RE: Request by Georgia Environmental Protection Division (EPD) to reduce flow from Lake Lanier for water quality from 750 cfs to 650 cfs this winter

Re: Proposed Modifications to Interim Operations Plan for ACF Reservoirs

I offer the following comments on the Corps' proposed modifications to the Interim Operations Plan ("MIOP") for its reservoirs in the Apalachicola-Chattahoochee-Flint ("ACF") River Basin on behalf of the Atlanta Regional Commission, the City of Atlanta, Georgia, Fulton County, DeKalb County, Cobb County-Marietta Water Authority, and the City of Gainesville, Georgia (collectively, the "Water Supply Providers"). Technical materials prepared by Megan Rivera, Ph.D. of Hydrologics, Inc. and George McMahon, Ph.D. of Arcadis are also attached.

Figure 1. Conservation Storage and Drainage Basin for ACF Reservoirs.

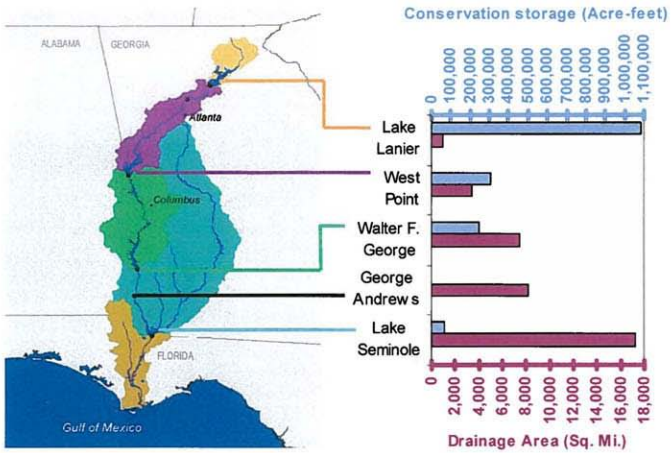
The reality is that only a small fraction of Basin Inflow can actually be captured in storage, regardless of what the MIOP might allow. The fraction of Basin Inflow that can be stored depends on the distribution of inflow in relation to storage. Of the 17,230 mi.^{2} drainage basin above Lake Seminole, 95% is below Lake Lanier, which represents 65% of total system storage; 80% is below West Point, which, together with Lake Lanier, represents 85% of total system storage; and 57% is below Walter F. George, which is the last storage project in the system. *See Figure 1.* In other words, run-off from 57% of the basin cannot be captured in any reservoir and 80% of the basin is controlled by the smallest storage project in the system, with only 244,000 acre-feet.

The end result is that only a small fraction of Basin Inflow can actually be captured and stored in the federal reservoirs, because of their location in the basin, no matter what the rules theoretically allow. For example, for the period from January 2007 to present, the MIOP provision allowing storage of up to 50% of Basin Inflow would result in the actual storage of only 8% of Basin Inflow—the remaining 92% would pass downstream to Florida. Similarly, for the period from 2003 to 2004, the Corps would actually be able to store only 1% of Basin Inflow under the MIOP, whereas 99% would be passed downstream to Florida.

Figure 2. Comparison of flows at the Chattahoochee gage under IOP and MIOP for period from January 2000 through December 2001.

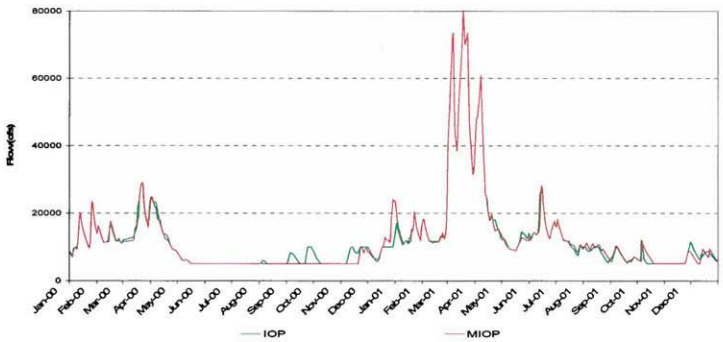
Because the Corps' ability to store water is so limited, the provision of the MIOP theoretically allowing storage of up to 50% of Basin Inflow cannot significantly impact flows in the Apalachicola River. Figure 2 through Figure 4 illustrate this point by comparing flows at the Chattahoochee gage under the IOP with those under the MIOP for three 2-year periods.[1] As these figures show, changes in storage limitations under the MIOP have virtually no effect on flows at the Florida line.

Figure 4. Comparison of flows at the Chattahoochee gage under IOP and MIOP for period from May 2007 through April 2008.

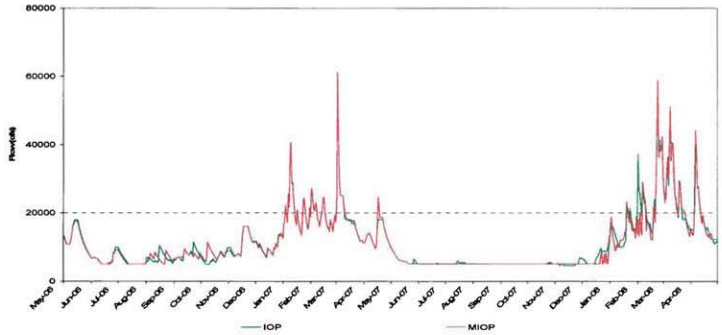
From this, two things are clear. First, Florida's argument that the MIOP will result in significantly reduced flows in the Apalachicola River is plainly not correct. Second, the Corps can and should utilize every opportunity to store water when such opportunities arise—and, given the placement of storage within the basin, such storage will have little appreciable effect on flows at the Florida line.

Figure 5. Flow at the Chattahoochee gage under MIOP as compared to flow under the "At Site Objectives" Operating plan.

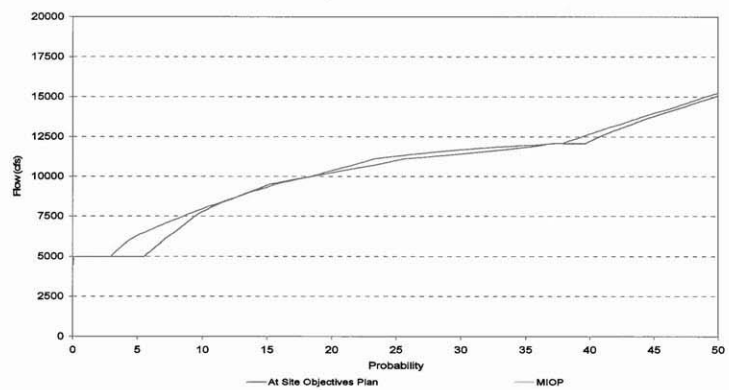
Figure 5 and Figure 6 show the cumulative distribution of flows at the Chattahoochee gage for the MIOP and the "At Site Objectives" Plan. Although the MIOP does provide slightly higher flows in the range between 5,000 cfs and 15,000 cfs, *see* Figure 5, the difference is remarkably small and insignificant over the entire range of flows. *See* Figure 6.

Figure 10. Average daily inflow (acre-feet per year) and conservation storage for ACF Reservoirs.

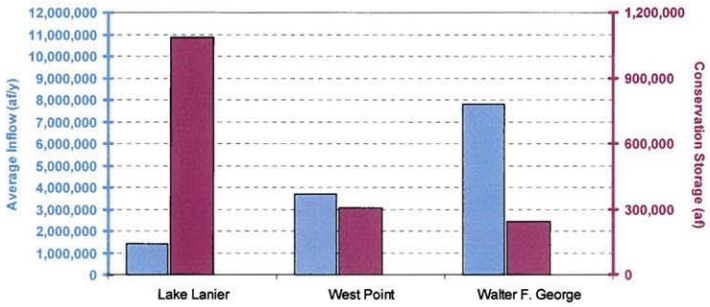
Figure 10 shows the average annual inflow (acre-feet per year) into each of the three storage reservoirs. 0 provides similar statistics in a different form. The table shows, for example, that the drainage-to-storage ratio for West Point is 100 times greater than that for Lake Lanier. 0 further shows that it would take 279 days to fill Lake Lanier *if the entire flow of the river (based on the annual average flow) were captured and stored.* This statistic is provided for purposes of comparison only—in reality it would take much longer than 279 days to refill Lanier because it will never be possible to capture and store 100% of the inflow to this reservoir.

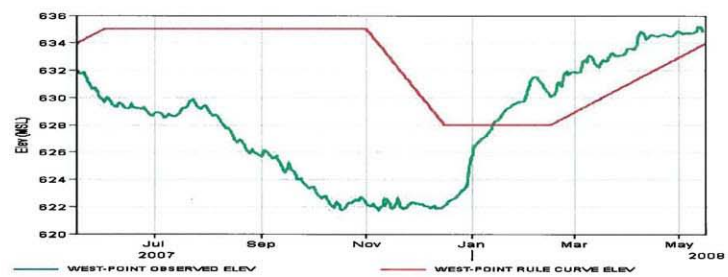
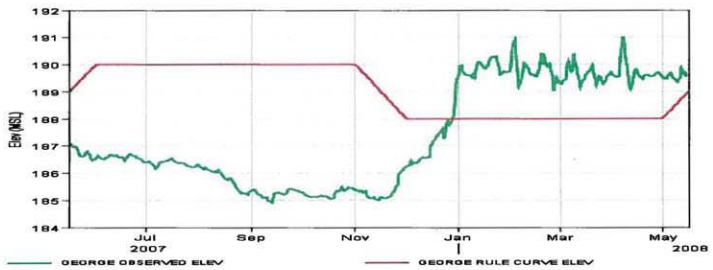
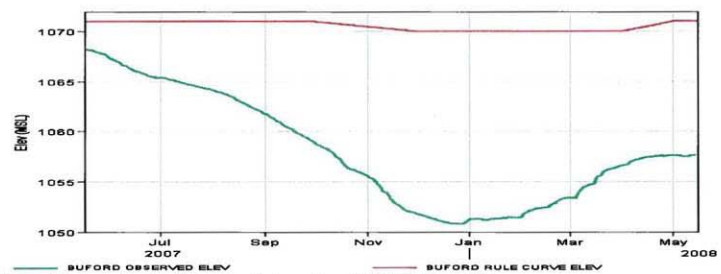
The events of 2007 illustrate the effect on Lanier's very small drainage-to-storage ratio. Figure 11 through Figure 13 show the actual, recorded levels for West Point, Walter F. George and Lake Lanier from June 2007 to May 2008. These Figures show that West Point and W.F. George responded almost immediately to the rains that began in November 2007. Even with reduced releases from Buford Dam, these reservoirs, which had been at the bottom of Zone 4, refilled completely by mid-January. In fact, both reservoirs are now *over* full, as defined by the "top of conservation" line in the graphs. In sharp contrast, Lanier is still fifteen feet below rule-curve—a record low for this time of year—and the level is projected to fall even further for the rest of the year.

Figure 14. Apalachicola River stage at Chattahoochee gage from April 28, 2008 to May 29, 2008.

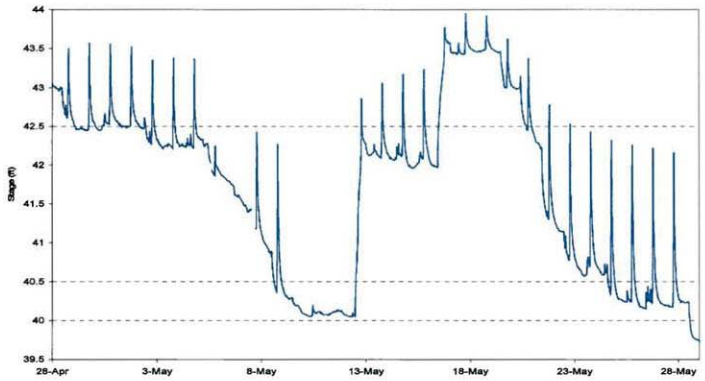
To put this in perspective, metropolitan Atlanta's average consumptive use of 250 cfs corresponds to approximately 1.8 inches in river stage at the Chattahoochee gage in the Apalachicola River at the river's lowest flow. This in a river that fluctuates wildly, often as much as 2 feet per day as a result of hydropower operations. *See* Figure 14.

Figure 15. Channel degradation in the Apalachicola River, from Helen R. Light, Water Level Decline in the Apalachicola River, Florida, from 1954 to 2004, and Effects on Floodplain Habitats (USGS Scientific Investigations Report 2006-5173) at 9 (Figure 4).

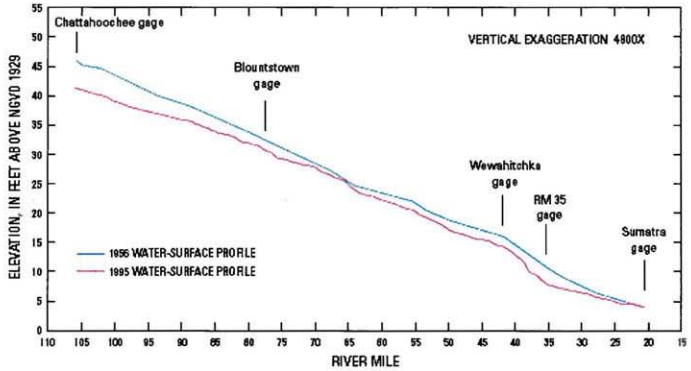
Similarly, to the extent Florida and the Corps are concerned about the areal extent of flooding or the amount of certain types of habitat that are inundated, Florida and the Corps must acknowledge that real causes of these problems have more to do with channel degradation than with the quantity of flow in the river. USGS has documented the effect of channel degradation in the Apalachicola River, which has substantially lowered the bed of the river in key places, such as the sturgeon spawning area at River Mile 105.5. *See Figure 15.* This is highly significant because many of the environmental issues in the Apalachicola River, and especially those related the Gulf sturgeon and mussels, have more to do with the areal extent of flooding or inundation as opposed to the quantity of flow *per se*. As a result of the lowering of the channel, it now takes much more water to achieve any given river stage. At the principal spawning ground for the sturgeon, RM 105.5, USGS has determined that an additional 10,000 cfs is required to raise the river its former stage. This is *40 times* the average annual consumptive use of the entire metropolitan area (250 cfs). *See Helen R. Light, Water Level Decline in the Apalachicola River, Florida, from 1954 to 2004, and Effects on Floodplain Habitats (USGS Scientific Investigations Report 2006-5173) at 25, Figure 13.*

Figure 16. Percentage of the Main Channel of the Apalachicola River Entering Chipola Cutoff from 1976 to 2004. From Administrative Record in State of Georgia v. U.S. Army Corps of Engineers (M.D. Fla. 07-cv-1) GAI001733.

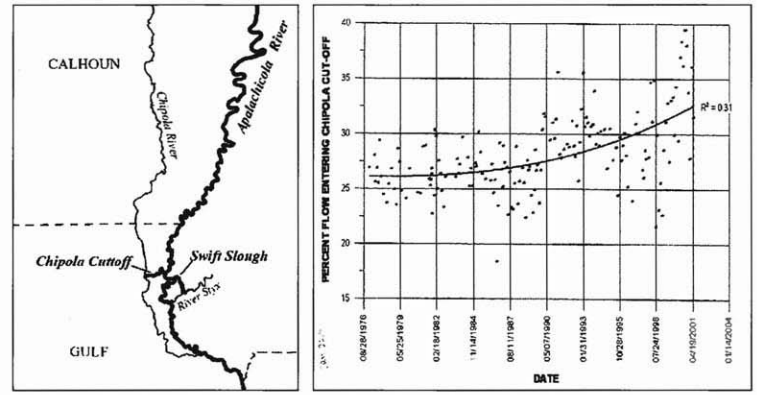
Likewise, the Apalachicola River appears to be migrating to the Chipola Cut-off, a man-made diversion that is claiming up to 40% of the flow of the mainstem of the river, according to the most recent statistics. This diversion is partially responsible, along with other factors such as the build-up of sediment at the head of the slough—for the dewatering of Swift Slough in 2006 and 2007. Water-use in the metro area pales in comparison to the amount diverted by this artificial cut-off. *See Figure 16.*
